Ordinary Meeting of the Council

MINUTES

Date:	Tuesday, 27 August 2019
Time:	7:00pm
Location:	Council Chamber, Civic Centre 699 Doncaster Road, Doncaster

9.1 Planning Application PLN18/0172 at 454-456 Doncaster Road, Doncaster for the use and development of a three-storey childcare centre plus associated basement and sub-basement car parking, to display a floodlit business identification sign, and alter access to a road in a Road Zone, Category 1

Figure 9 - Sensitivity plan of Subject Site

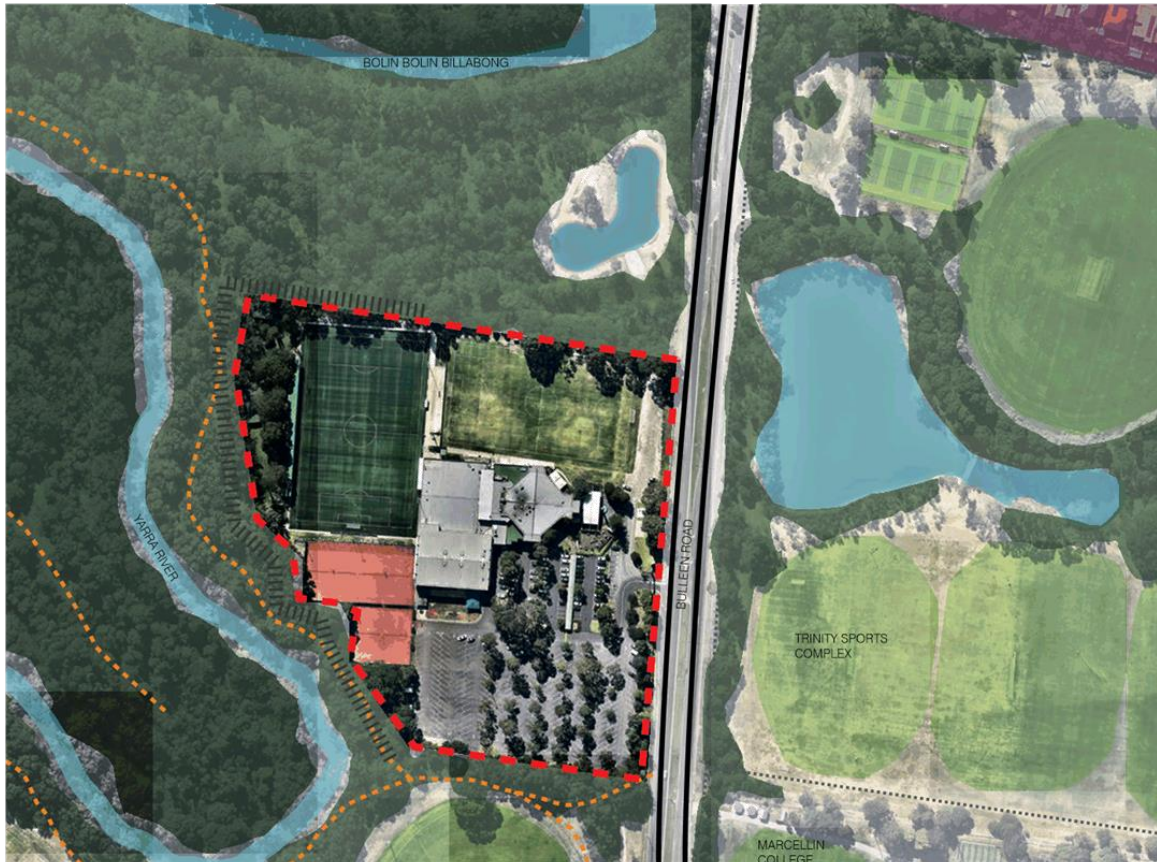
- c) The landscape objective under Stage 2 on page 20 stating: “*To ensure new landscaping incorporates native species*” be deleted.
- d) Amend the Sensitivity Plan (Figure 9, p11) in the Development Plan to show an extension of the ‘*Interface of Importance*’ along the full extent of the northern boundary of the Veneto Club.

- 2.35 It is also noted that the Veneto Club adjoins the Bolin Bolin Billabong to the north which is a significant and sensitive interface.
- 2.36 The ‘*Sensitivity Plan*’ on p 11 at Figure 9 of the Development Plan does not show the interface of importance extending for the entire northern boundary. It is recommended that this plan be amended to show the interface being extended along this boundary and an additional dot point be included on p11 to acknowledge the proximity to the Bolin Bolin Billabong as a sensitivity associated with the site.

- 2.38.4 The landscape objective under Stage 2 on page 20 stating: "*To ensure new landscaping incorporates native species*": be deleted.
- 2.38.5 Amend the Sensitivity Plan (Figure 9, p11) in the Development Plan to show an extension of the *'Interface of Importance'* along the full extent of the northern boundary of the Veneto Club.
